**KNOXVILLE/KNOX COUNTY METROPOLITAN PLANNING COMMISSION  
SUBDIVISION REPORT - CONCEPT**

▶ **FILE #:** 1-SA-14-C

▶ **SUBDIVISION:** RUSHLAND PARK, PHASE IV

**1-SA-14-C  
CONCEPT PLAN**

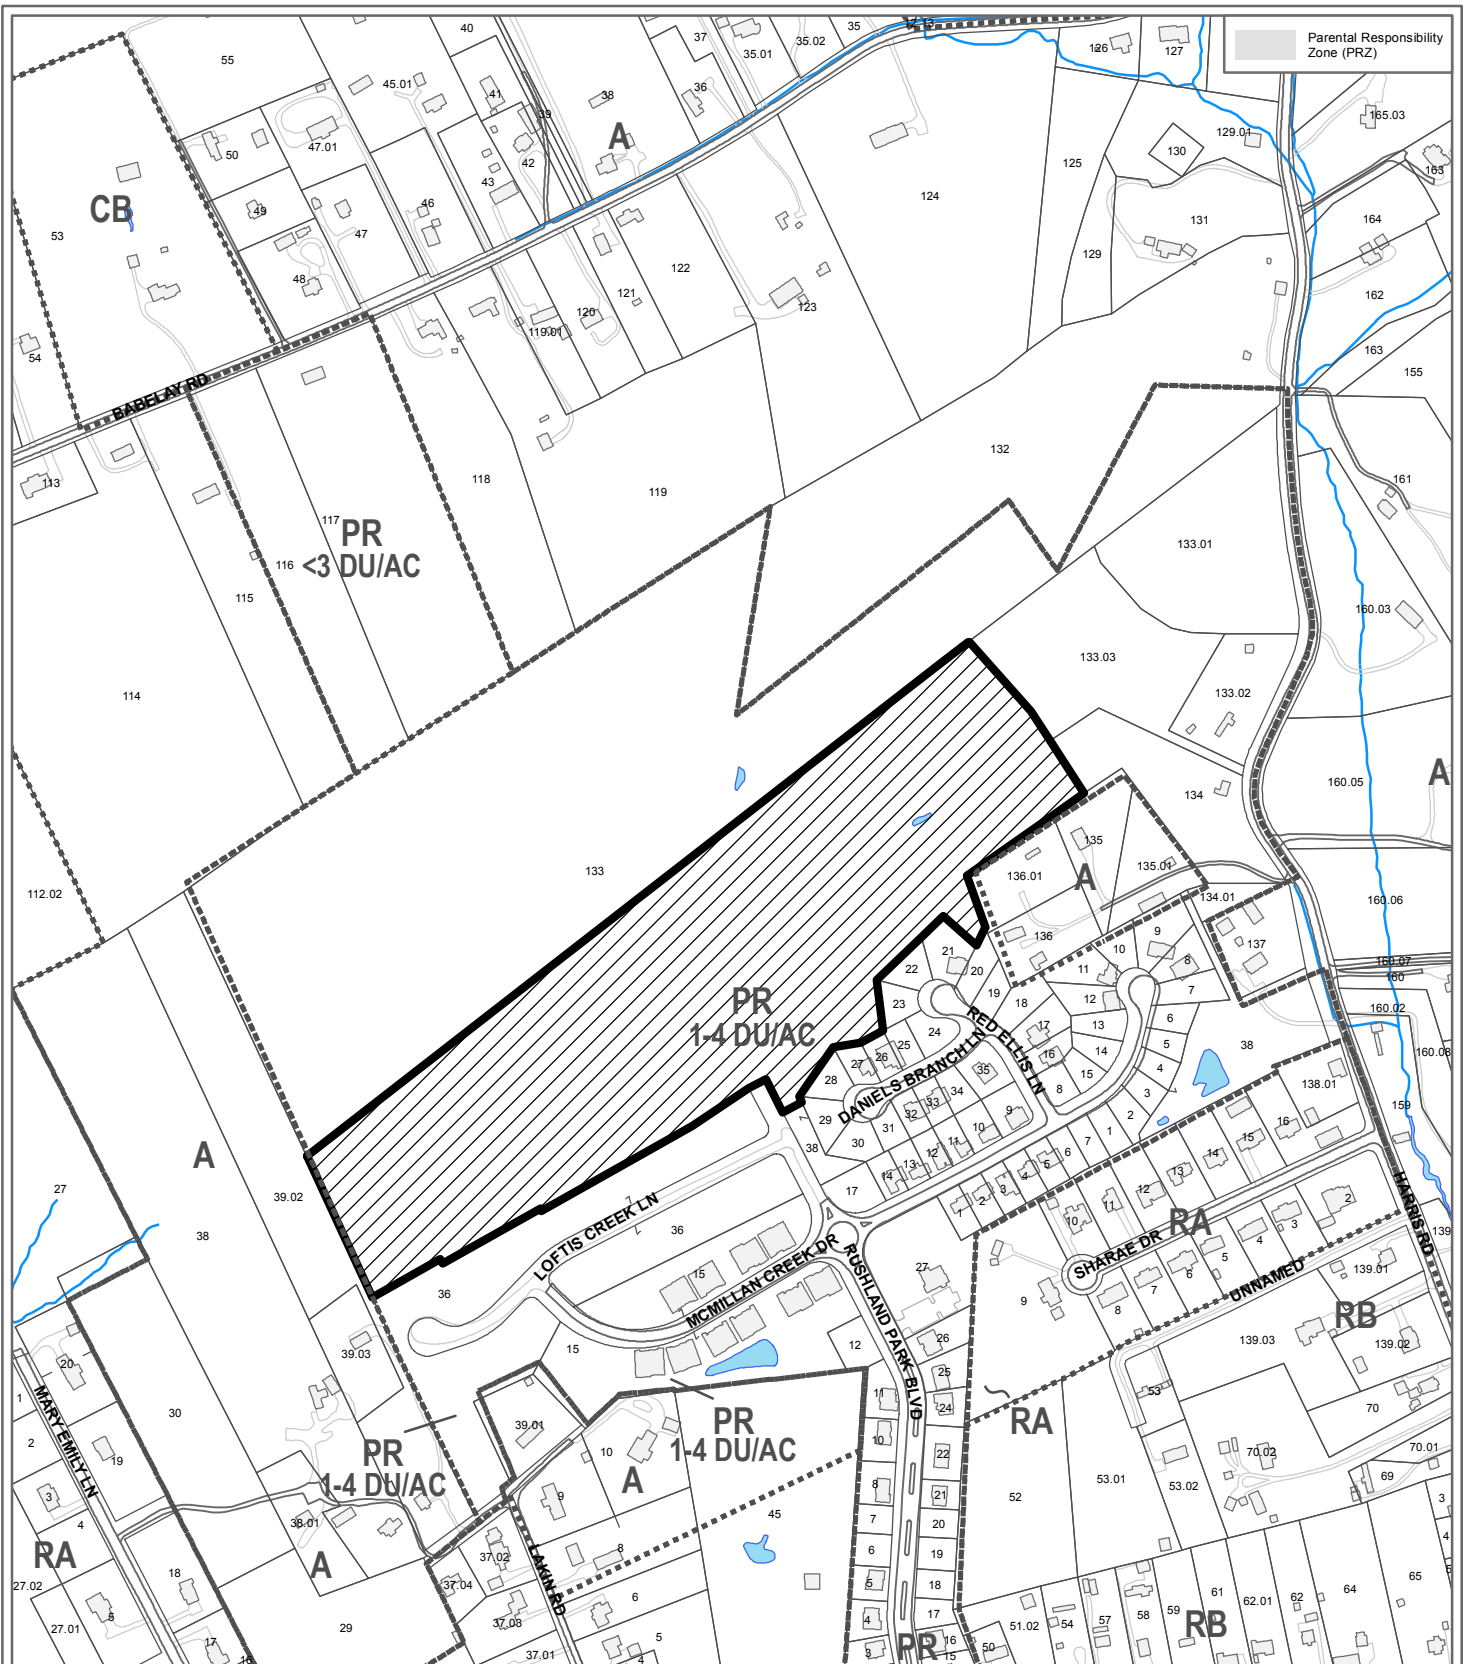
1. Vertical curve variance at STA 2+45 on Rushland Park Blvd., from 157' to 77.9'.
2. Vertical curve variance at STA 6+87 on Rushland Park Blvd., from 250' to 100'.
3. Vertical curve variance at STA 0+70 on 40' JPE, from 225' to 140'.

▶ **APPROVE** variances 1-3 because the site's topography restricts compliance with the Subdivision Regulations, and the variances will not create a traffic hazard.

**APPROVE** the concept plan for up to 46 detached residential lots subject to 7 conditions.

1. Connection to sanitary sewer and meeting any other relevant requirements of the Knox County Health Department.
2. Provision of street names which are consistent with the Uniform Street Naming and Addressing System within Knox County (91-1-102)
3. Installation of sidewalks as identified on the concept plan. Sidewalks shall meet all applicable requirements
